Hillsides Master Development Plan Phase 4

940 Avenue 64
Pasadena, California 91105

Historical Evaluation of Proposed Rehabilitation

Historical Evaluation of Proposed Rehabilitation

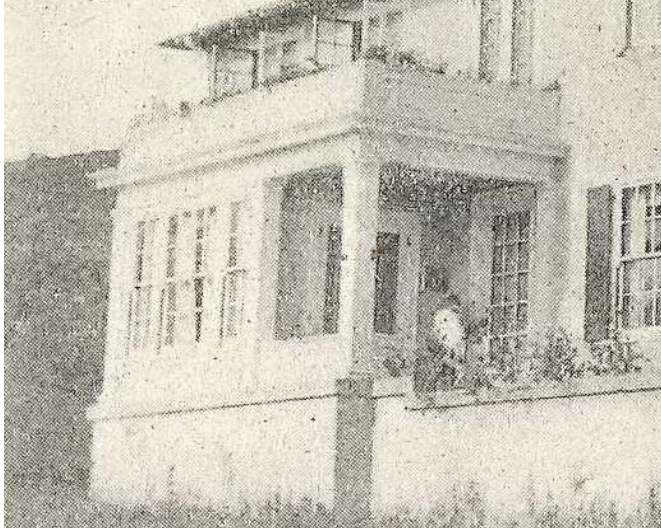
Photos of Affected Areas: Administration Building	
	<p>South end. View of area where largest proposed addition, to contain a conference room and restrooms, will be located. Proposed addition is two stories high with a hipped roof, set back from the front façade of the building by approximately eight feet, and with a lower, separate hipped roofline. Existing openings on this side façade will be removed.</p> <p>Shed (not a historic feature) will be removed and addition will be located approximately on the platform seen at center.</p>
	<p>South end. Removal of non-historic stairs at right (on South Annex) will create more room for the proposed addition to the south end of the Administration Building (left).</p>

Photos of Affected Areas: Administration Building	
	South end. Shed and current south exit staircase will be removed from south end of the Administration Building. Two-story conference room and restroom addition with exterior, rear and side staircase will be constructed in this location.
	North end. Non-historic rear additions pictured will be removed from the north end of the Administration Building.
	North end. Two-story enclosed exit stair to be added in this location, the north end of the Administration Building. Proposed addition is 9' x 17' 2" in plan, two stories high with a hipped roof, set back from the front façade of the building by approximately three feet, and with a lower, separate hipped roofline. Nonhistoric stairs and existing openings on this side façade will be removed.

**Administration Building
Exterior Rehabilitation Recommendations**

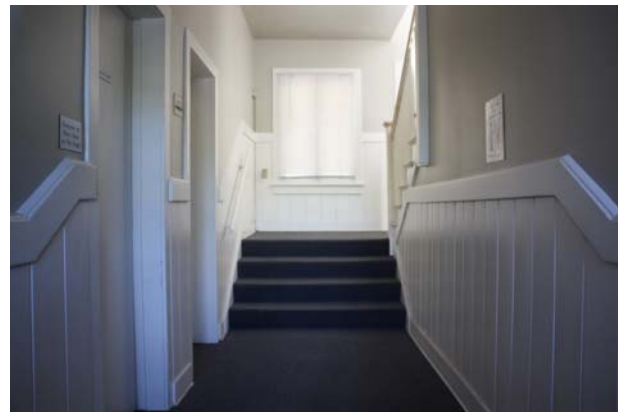
Recent window replacements in this porch are double-hung windows instead of the historical type, which, seen here, were casement sash. Acceptable to maintain current replacements, which are compatible with the style and era of the building.

Central bay of front porch was originally closed. Acceptable to maintain this alteration for passage to the center of the façade. Maintain the low wood walls in adjacent bays.

Replace all aluminum frame windows on second floor with two or four casement sash (according to opening size, which indicates original configuration).

Remove wall air conditioners. Replace aluminum vertically sliding windows with 8-light wood casement sash according to model of historic photos.

Retain character-defining entrances and exits. The appearance of this entrance was restored after being closed for many years.

Replace wall light fixtures on main facade of building with a more compatible fixture. A very simple yet less utilitarian fixture is preferred.

NORTH ANNEX: Recommended exterior rehabilitation items based on historic appearance (includes porch rehabilitation in order to provide comprehensive information).

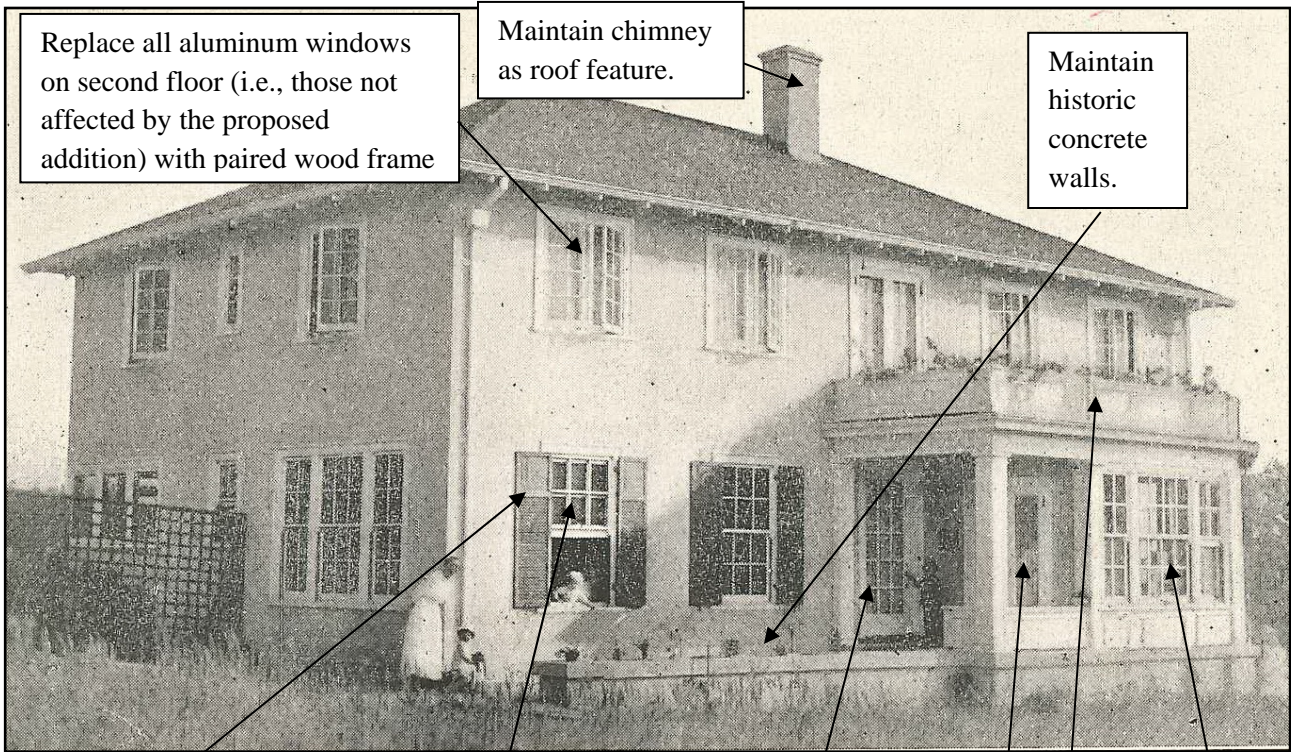
Maintain second floor doors, but restrict access to porch roof. Repair doors, or replace in kind (same materials and design) if original cannot be repaired.

Maintain chimney as roof feature.

Replace all aluminum windows on second floor (i.e., those not affected by the proposed addition) with paired wood frame casement sash.

Maintain historic concrete walls and steps.

Maintain and repair the historic windows on the enclosed porch and adjacent areas.

Install new three by five light wood frame entry door to replicate original.

Install new pair of wood frame, two by five light doors (with wood screens if desired, as shown in detail of historic photo at right).

Install replica wood shutters at both front windows, where missing (see detail below right).

Replace front vinyl windows with double-hung wood frame windows, six over six as shown.

Design of the balcony rail appears to be similar to the design of the lower panels of the porch (below the windows). The new rail should be based on this design to restore the integrity of the porch. Returning the porches to their original appearance is among the goals of the Master Plan Phase 4.
